ADA Curb Ramp New Construction Inspection Form (Parallel)

NW Curtis St

23885.56

NW Highland Ct

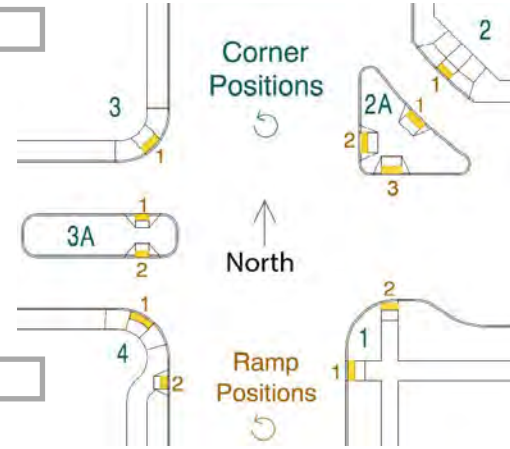
3.6 $\leq 2.0\%$ ☐ $> 2.0\%$ ☒

9.4 $\leq 8.3\%$ ☐ $> 8.3\%$ ☒

3.2 $\leq 2.0\%$ ☐ $> 2.0\%$ ☒

2.1 $\leq 2.0\%$ ☐ $> 2.0\%$ ☒

3.6 $\leq 2.0\%$ ☐ $> 2.0\%$ ☒
